Re: **Third Addendum to Remedial Action Work Plan  
90-30 Metropolitan Avenue, Rego Park, Queens, NY  
NYSDEC Site V00253-2  
FPM File No. 788-05-07**

In accordance with your August 2, 2006 email and our discussions on September 7, 2006, FPM Group (FPM) is hereby submitting this Third Addendum to the Remedial Action Work Plan (RAWP) for the above-referenced site for your review. This Third Addendum addresses the issue of the requested additional remediation wells in the western impacted area of the site.

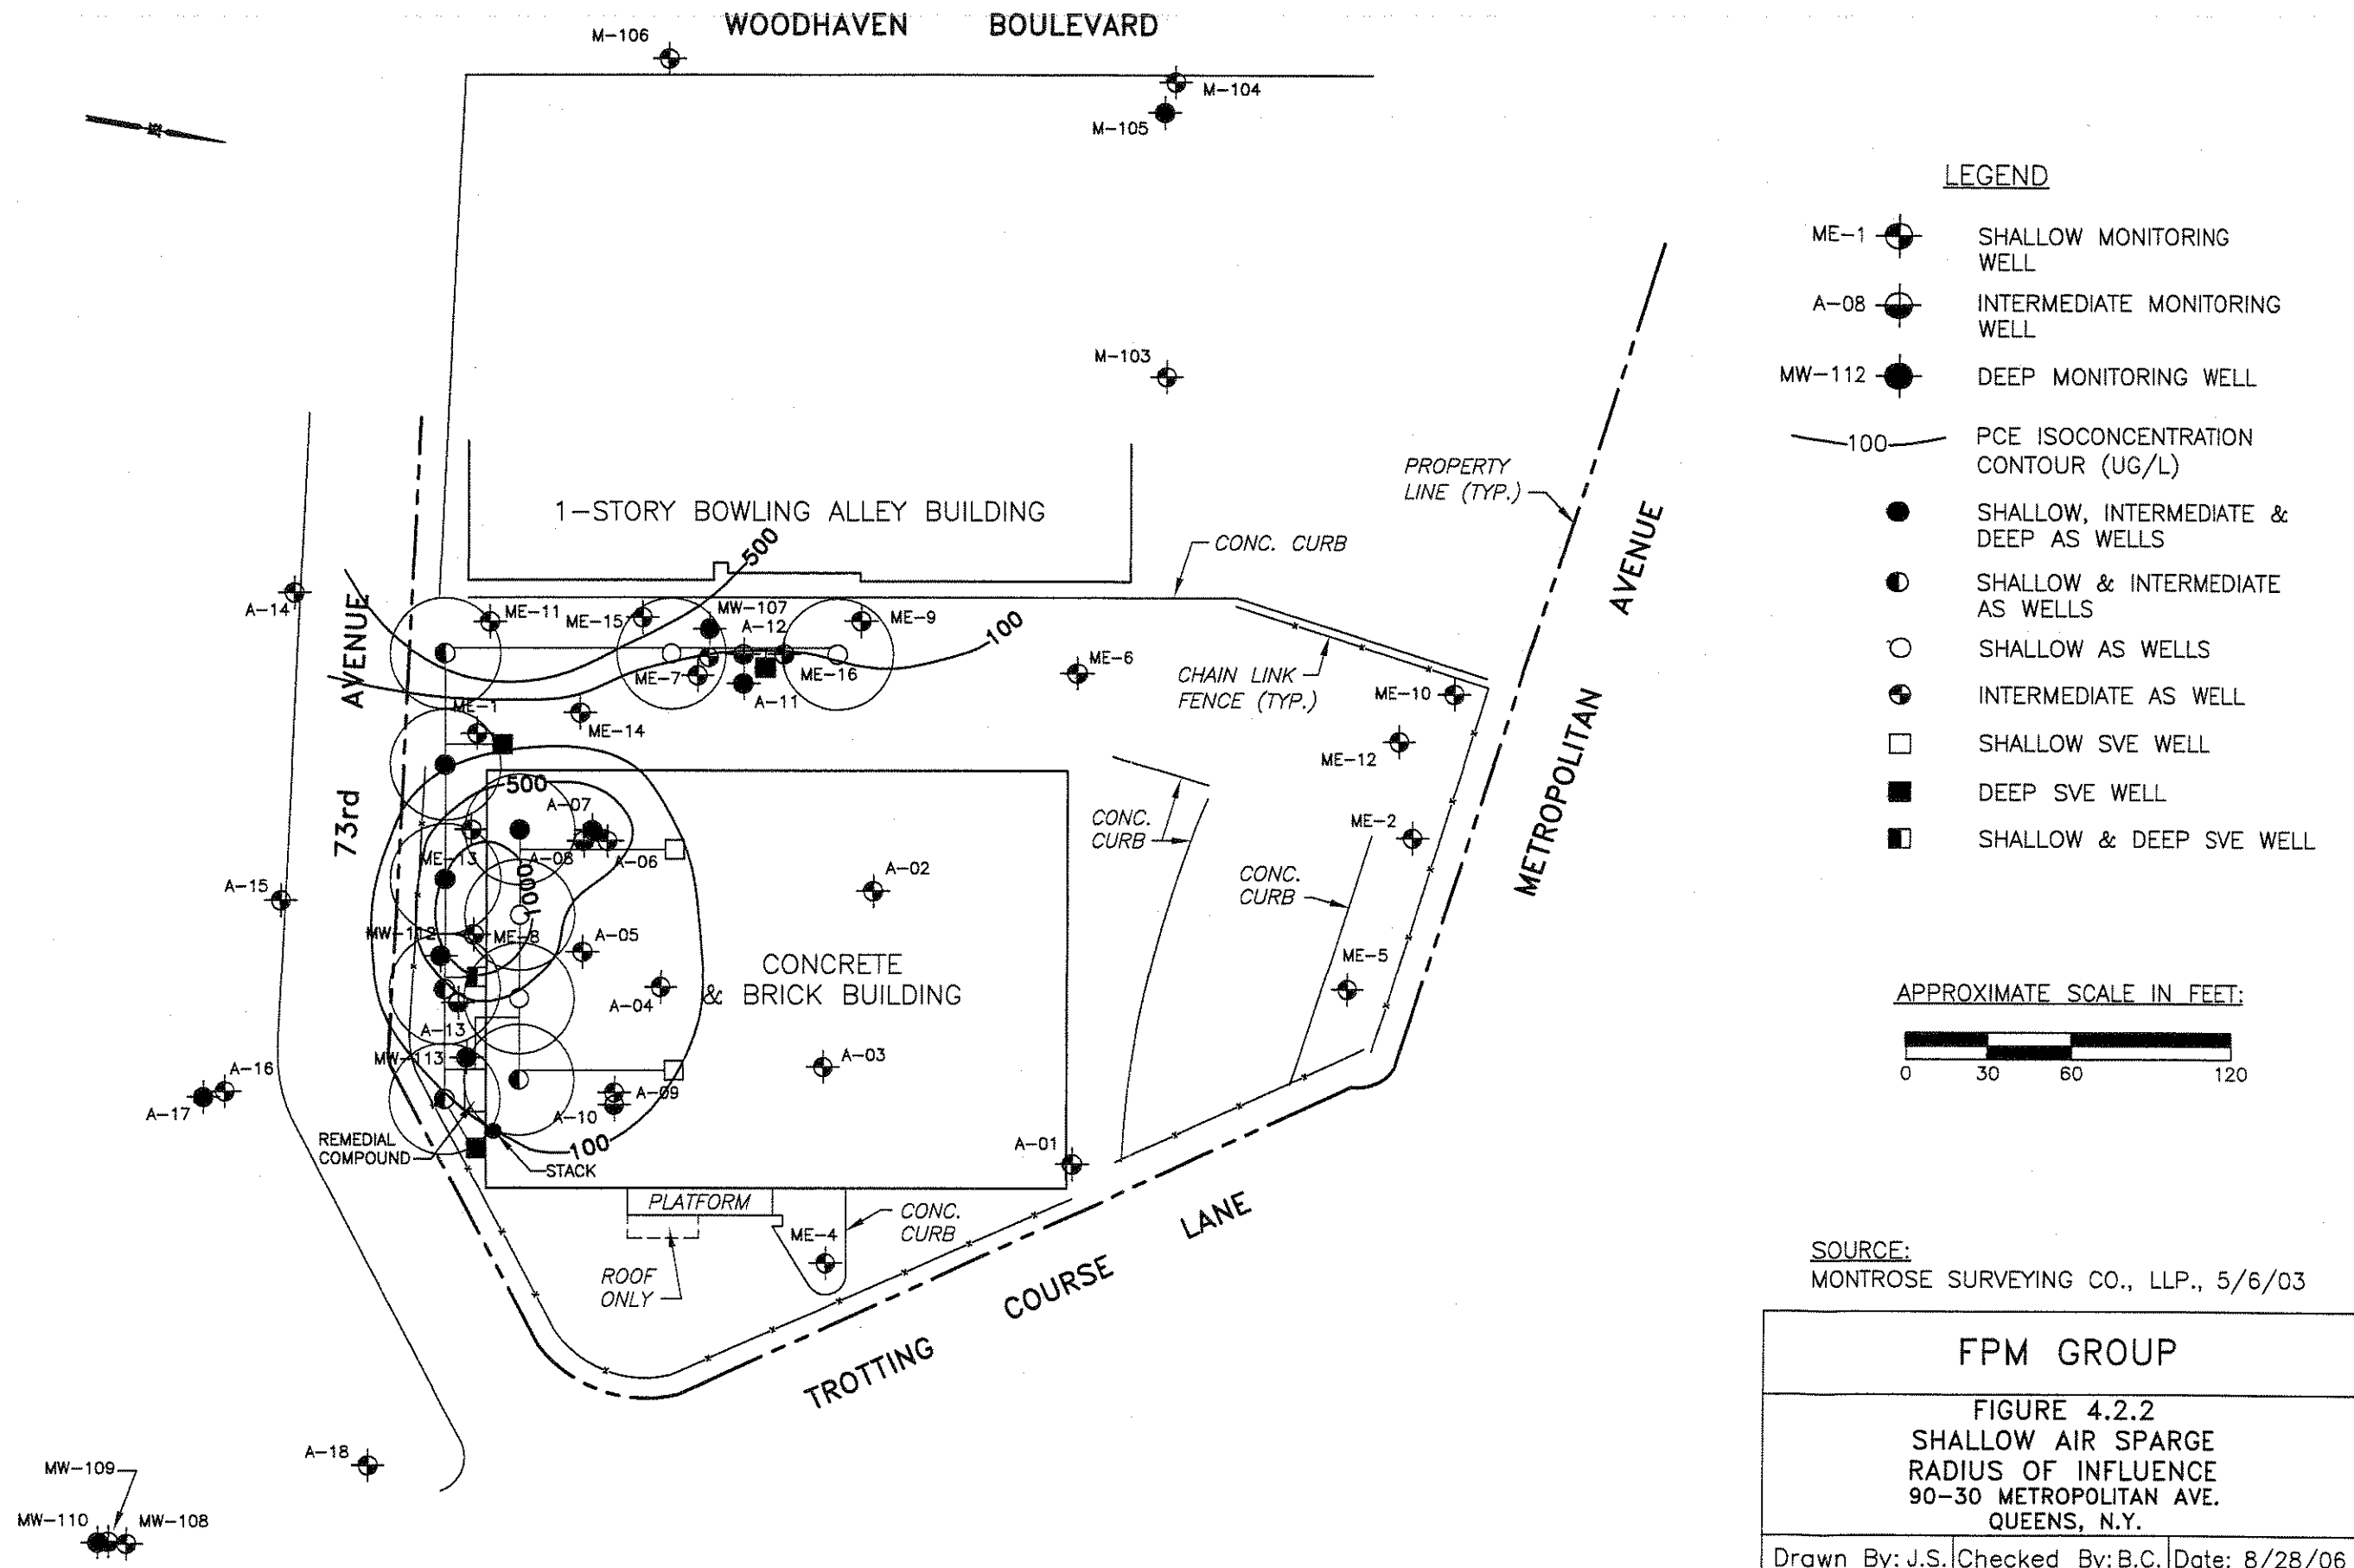
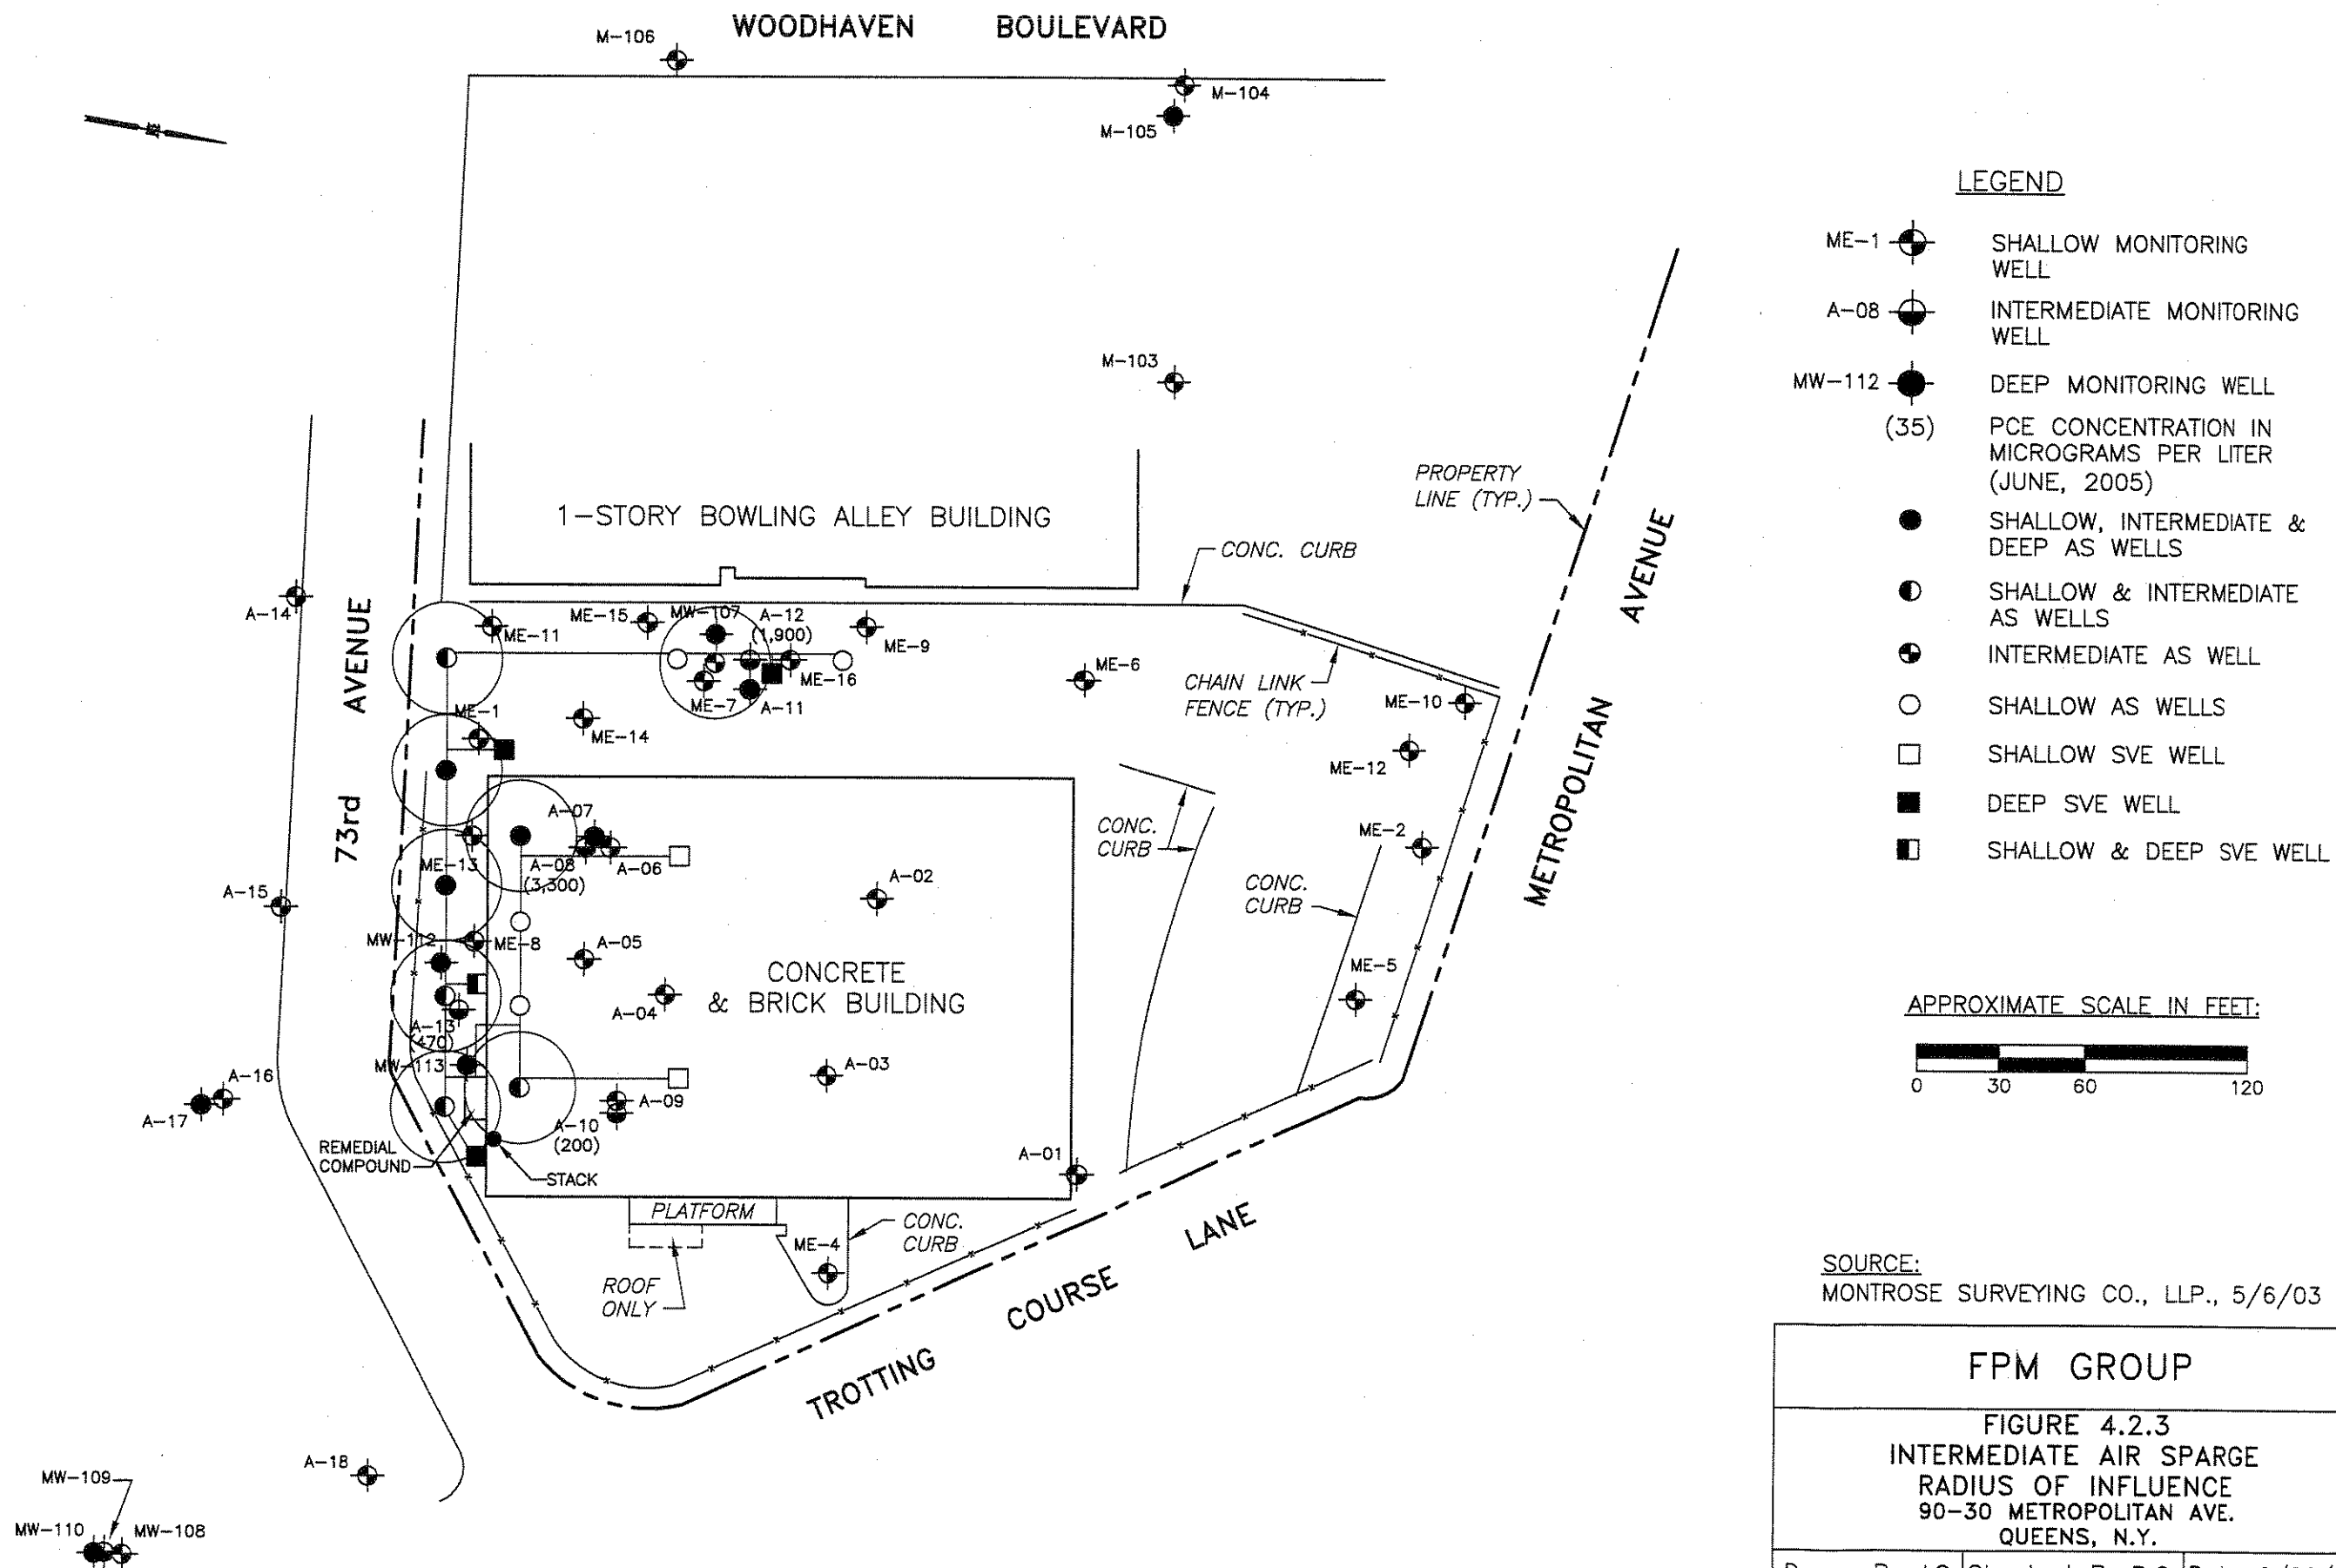
The Volunteer has agreed to install additional remedial wells on the western side of the site to address an area of PCE-impacted groundwater near the property line, as shown on the attached Figure 4.2.2. It is intended that these western wells be used to treat the impacted groundwater that is onsite; no offsite treatment is proposed.

The proposed wells for the western system include two shallow air sparge (AS) wells, one intermediate AS well, and one deep SVE well. The locations of these proposed wells are shown on the attached figures together with the estimated radii of influence.
